## STAFF REPORT

APPLICATION RZ/FDP 2008-MD-003

**APPLICANT:** Hilltop Sand & Gravel Company, Inc.

# HILLTOP VILLAGE CENTER

RZ 2008-MD-003  
Hilltop Village Center  
Conceptual Development Plan /  
Final Development Plan

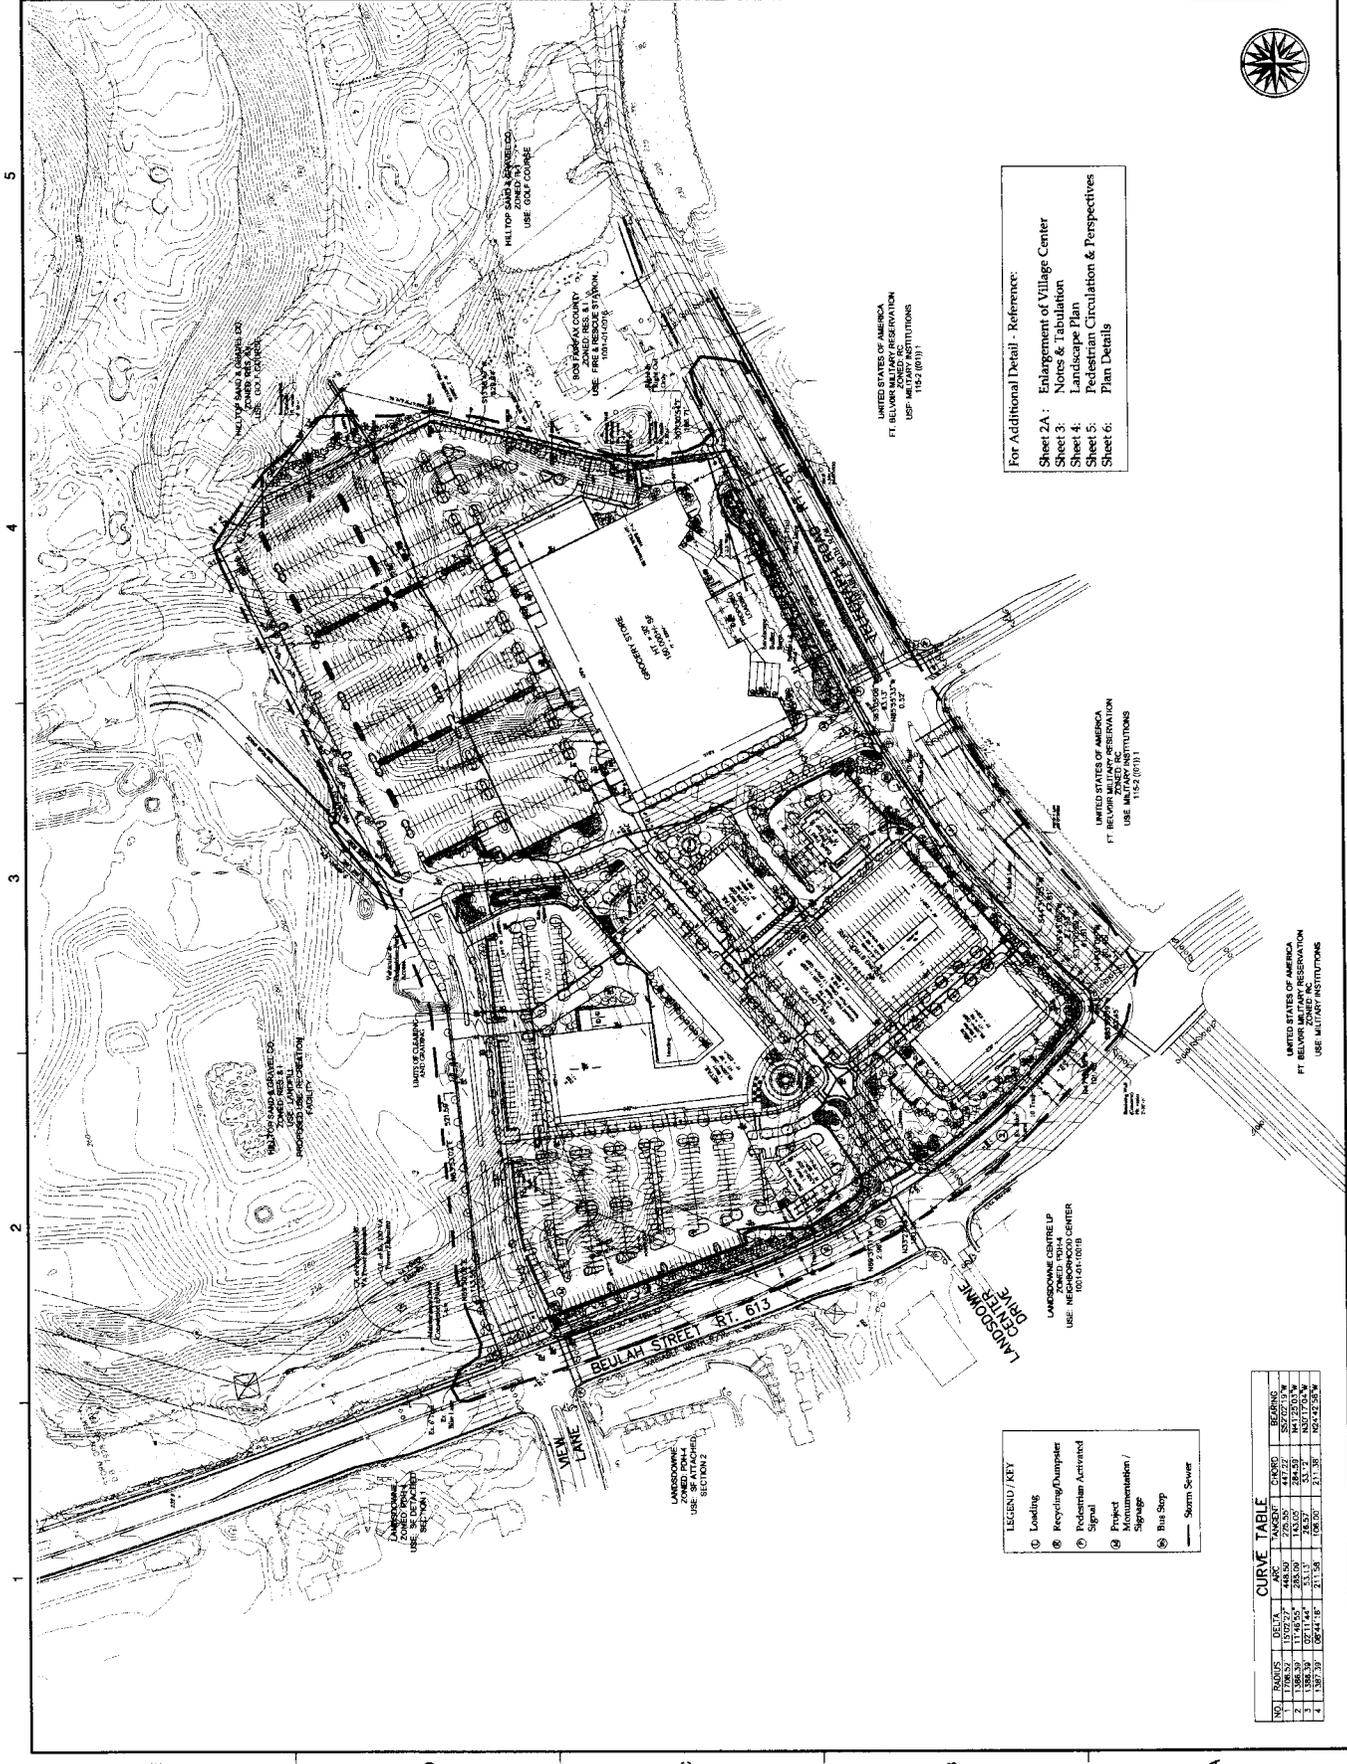
Staff has encouraged the applicant to incorporate the use of low impact development (LID) practices as a means of enhancing the proposed water quality control measures. While the CDP/FDP only depicts one rain garden in the north-central portion of the site, the proffers provide an additional commitment to LID measures within the site, such as, bioretention, vegetated swales, filter strips, permeable pavers, rain barrels, and tree box filters. Staff has concluded that while this commitment is rather limited in scope at this time, the proposed LID measures satisfy staff concerns regarding water quality controls for the proposed development.

REVISIONS  
 DRAWN BY: DAC  
 APPROVED BY: DAC  
 CHECKED BY: DAC  
 DATE: FEBRUARY 12, 2009  
 TITLE: HILLTOP VILLAGE CENTER  
 CDP / FDP  
 Details

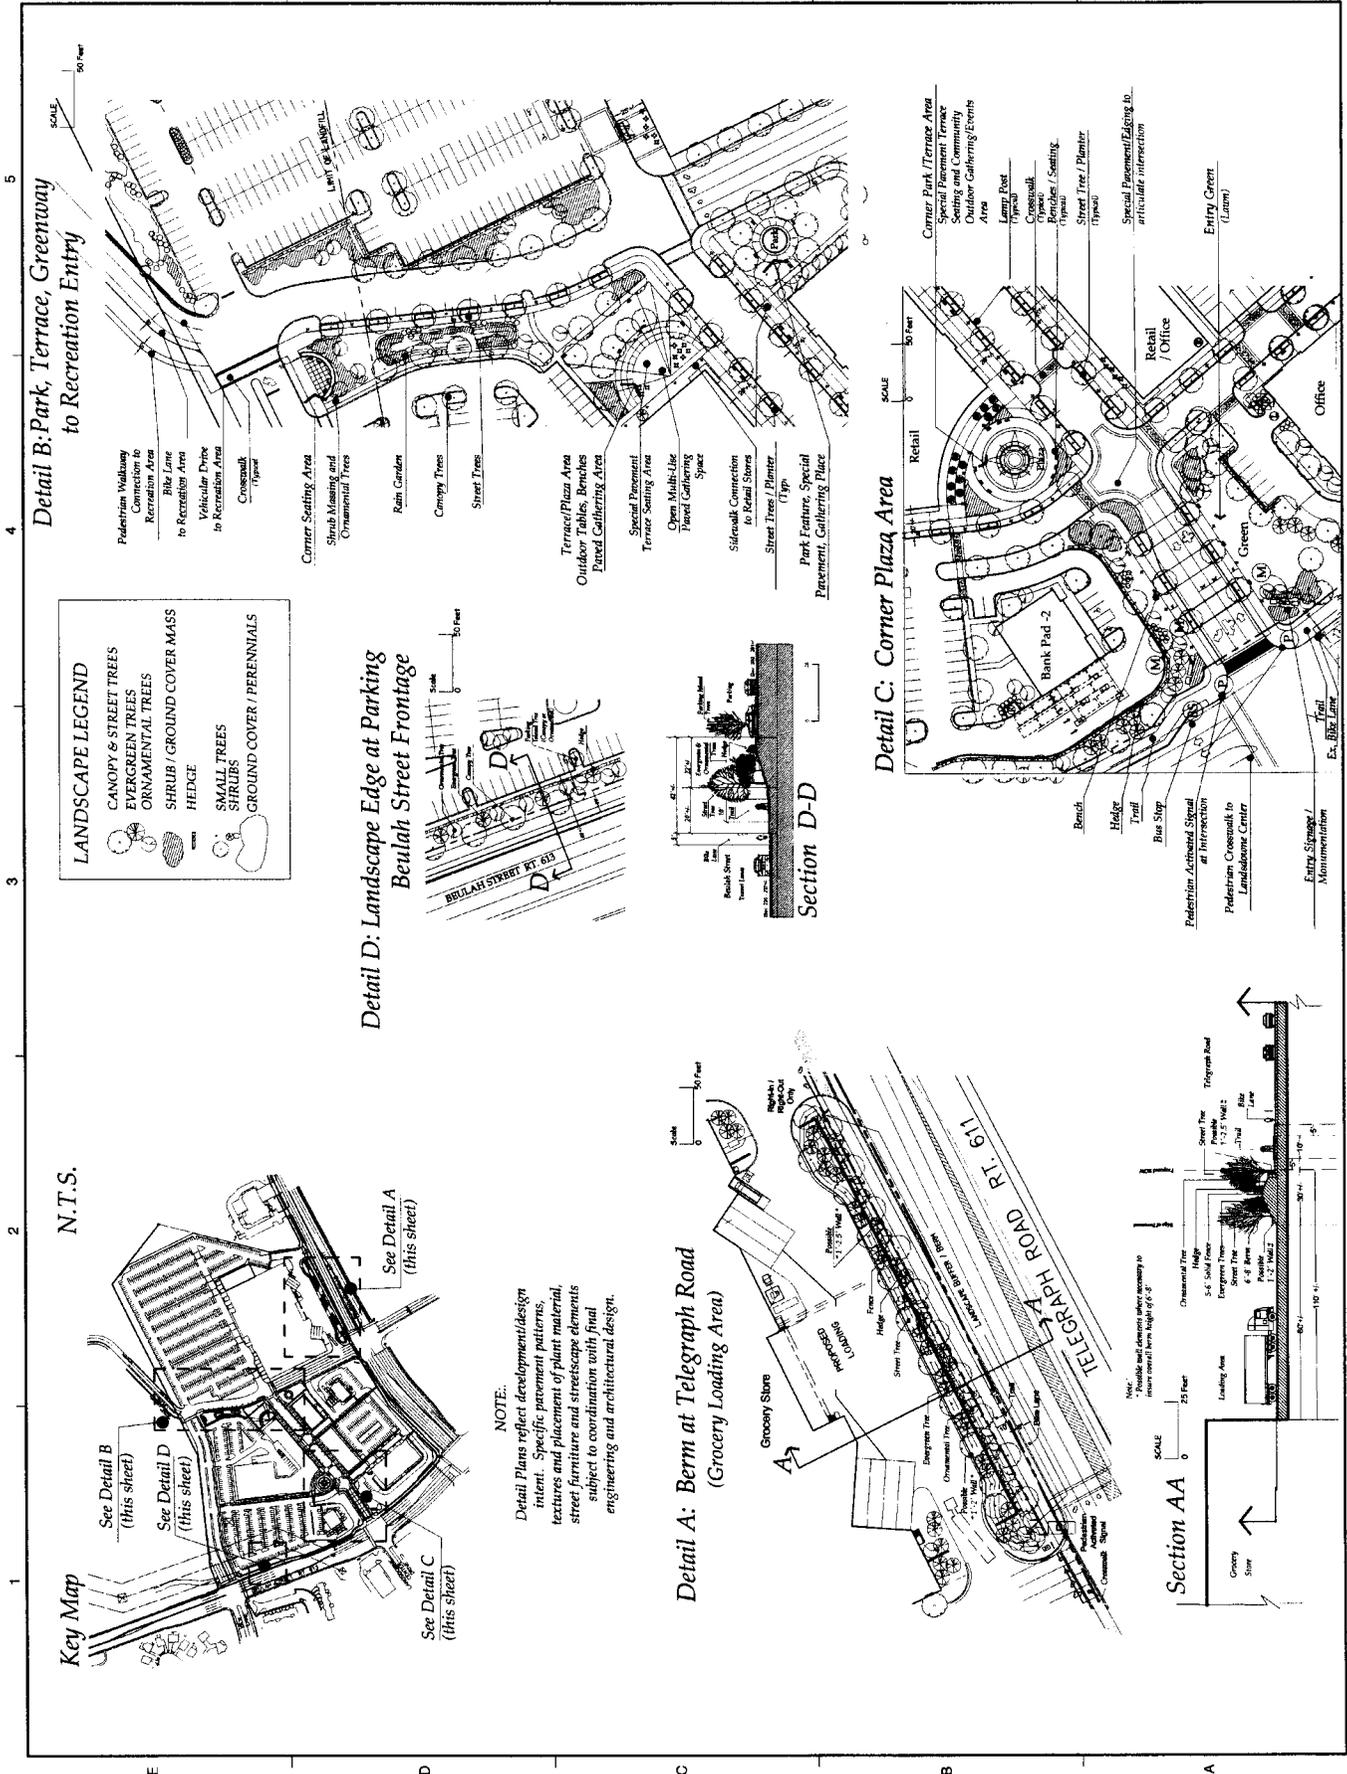
- As described above, the urban design of the site includes streetscapes with trees, other landscaping, sidewalks, bicycle facilities, street furniture and paving techniques as illustrated on the detail sheet within the CDP/FDP.
